# Access Compliance Report

## Public Rights-of-Way

### (Pedestrian Signals)

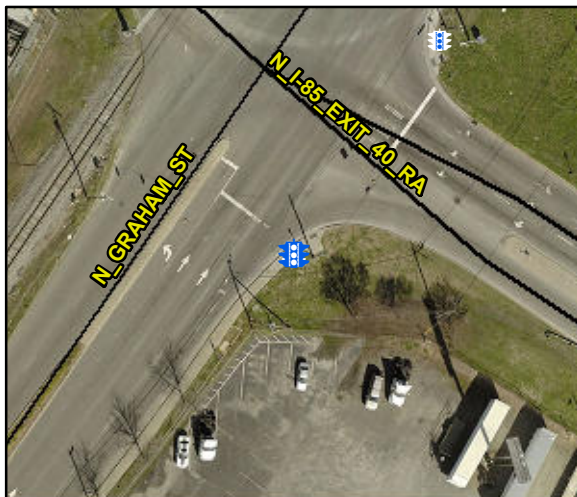
Surveyor Notes: TEXT HT 5/16

Yes	B 1 Clear Xing Direction?	ClearlyMarked	N/A	B 2 Clear Xing Direction?	N/A
	B 1 Crossing Direction	To NE		B 2 Crossing Direction	N/A
Yes	B 1 DistanceTo XWalk (in)	0.0	N/A	B 2 DistanceTo XWalk (in)	N/A
No	B 1 DistanceTo Curb (in)	133.0	N/A	B 2 DistanceTo Curb (in)	N/A
Yes	B 1 Diameter (in)	2.0	N/A	B 2 Diameter (in)	N/A

Possible Solutions: Replace Signal Push Button With APS Button on New Post. Remove & Replace Sign.
